# City of Santa Fe, New Mexico

# memo

**2025-010873-HDRB, 219 and 219 A Washington Ave**, Downtown and Eastside Historic District, Contributing, Robert Evans, agent for Dennis Price, owner, requests approval for a 1,357 sq. ft. addition including a two-story structure to a height of 22'-0" at 219 Washington Ave and construct a new 1,661 sq. ft. two-story structure at 219 A Washington Ave to a height of 24'-6" where the max allowable is 20'-1". Exceptions are requested to 14-5.2(D)(2)(d) an addition shall not exceed fifty percent of the square footage of the existing footprint and 14-5.2(D)(9) height.

**Figure 2. 219 Washington Ave proposed addition street facing façade.**

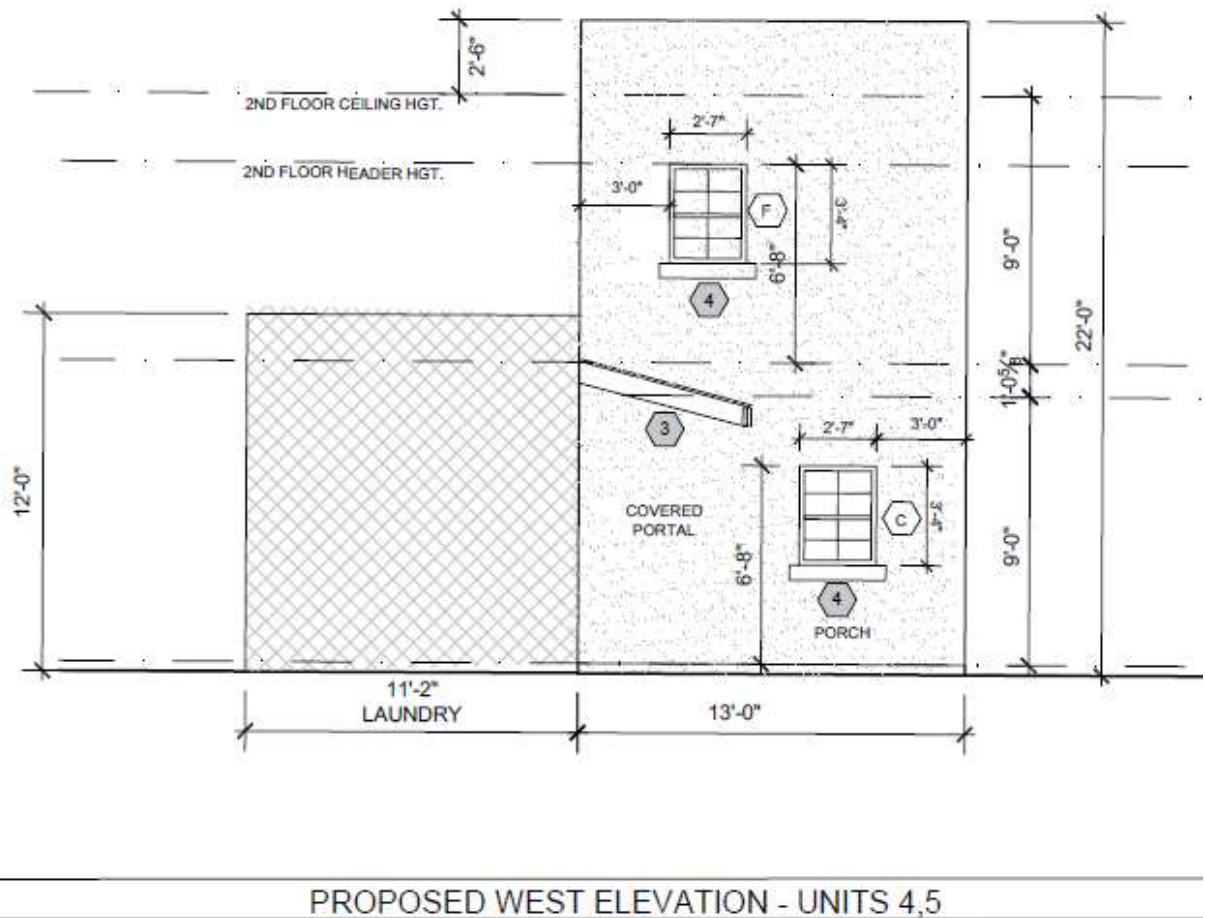
Exception to 14-5.2(D)(2)(d) an addition shall not exceed fifty percent of the square footage of the existing footprint: Staff requested an exception to 14-5.2(D)(2)(d) due to the proposed 628 sq. ft. of additions exceeds fifty percent of the existing footprint of 897 sq. ft.

Staff Response: Staff has evaluated the applicant's response and finds that the criterion has been met. The original structure at 219 Washington Ave served as a garage. It was renovated and became office space. The proposed development of the property will not impact the contributing status or the west primary street facing façade. The additional square footage is necessary for the remodeling of the structure from professional office space to hotel space.

Staff Response: Staff has evaluated the applicant's response and finds that the criterion has been met. The proposed development of the property will not impact the contributing status or the west primary street facing façade. The additional square footage will be minimally visible and not adversely impact the Washington Ave streetscape.

Staff recommends approval of the proposed project and finds that all the exception criteria have been met and that the application complies with Section 14-5.2(D) General Design Standards for all Historic Districts, and 14-5.2(E) Downtown and Eastside Design Standards.

Figure 3. 219A Washington Ave proposed new construction street facing façade.

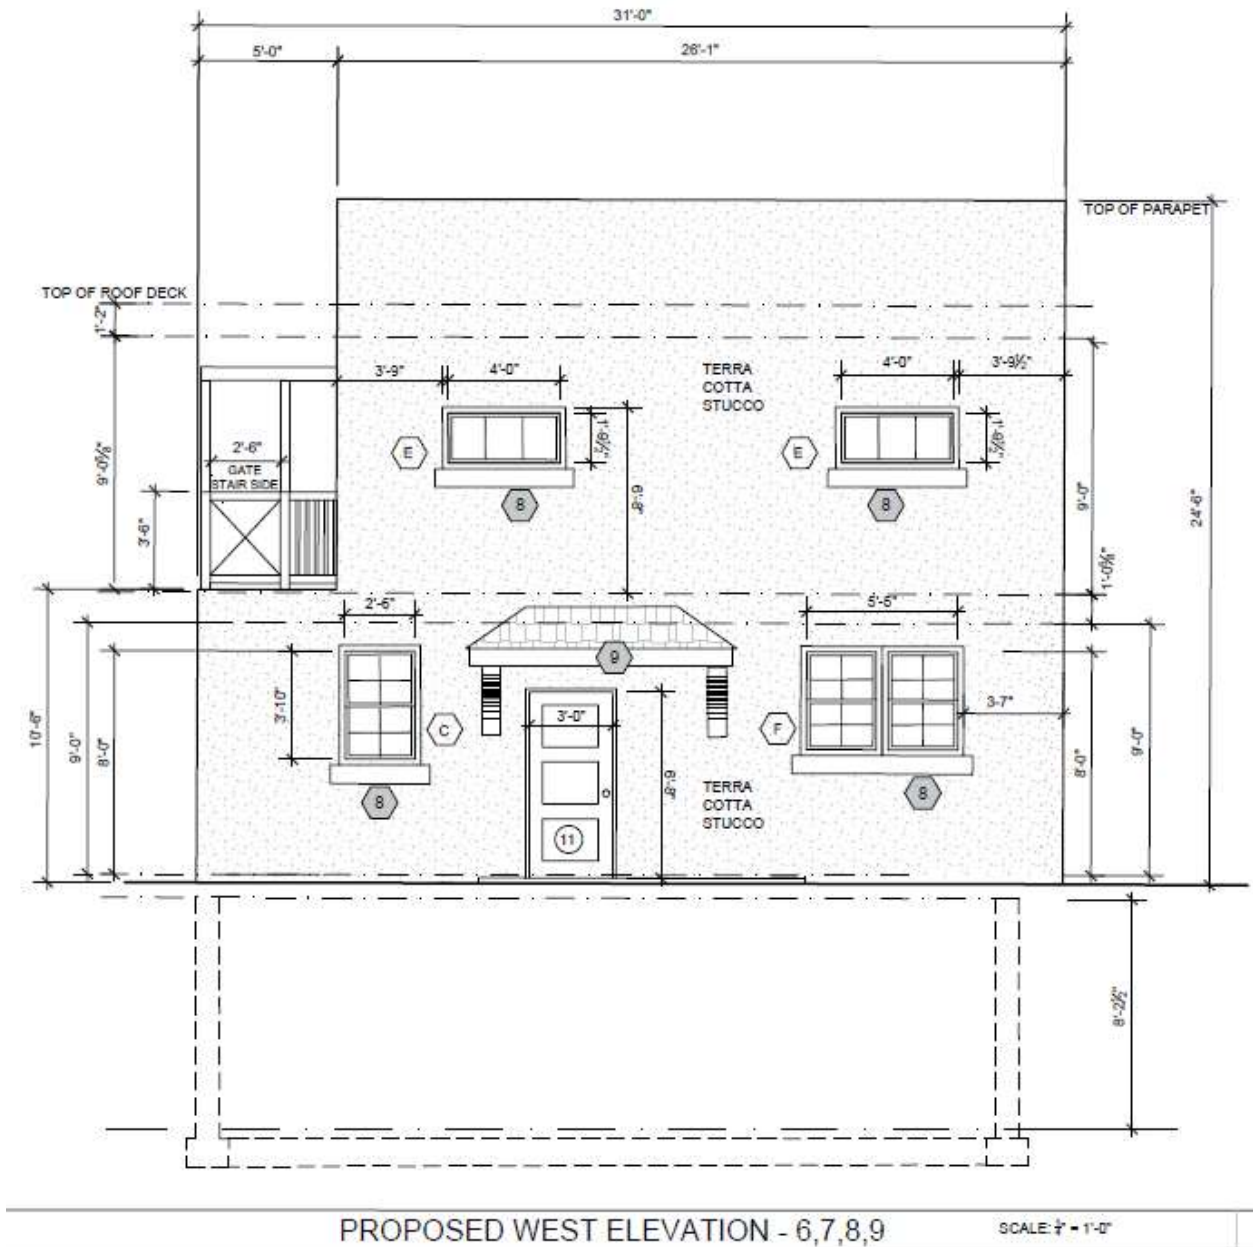
Exception to 14-5.2(D)(9) height: Staff requested an exception to 14-5.2(D)(9) for proposing a design that exceeds the maximum allowable height of 20'-1" to 22' and 24'-6" respectively.

Staff Response: Staff has evaluated the applicant's response and finds that the criterion has been met. The proposed height of 22' at (219) and 24'-6" at (219A) is greater than the

maximum allowable height of 20'-1" by 1'-11" to 4'-5" respectively. The adjacent two-story building at 215 Washington Ave is currently 29'-8" high. The variation of the proposed (219A) will be 5'-2" shorter than (215) which will provide less of a visual impact on the streetscape and will not impact the contributing structures in the vicinity adversely.

Staff Response: Staff has evaluated the applicant's response and finds that the criterion has been met. The proposed height of 22' at (219) and 24'-6" at (219A) is greater than the maximum allowable height of 20'-1" by 1'-11" to 4'-5" respectively, however is 5'-2" shorter than the adjacent two-story building at 215 Washington Ave. The variation of the proposed (219A) will provide less of a visual impact on the streetscape and will not impact the contributing structures in the vicinity adversely given it will be stepped back to the east from Washington Ave.
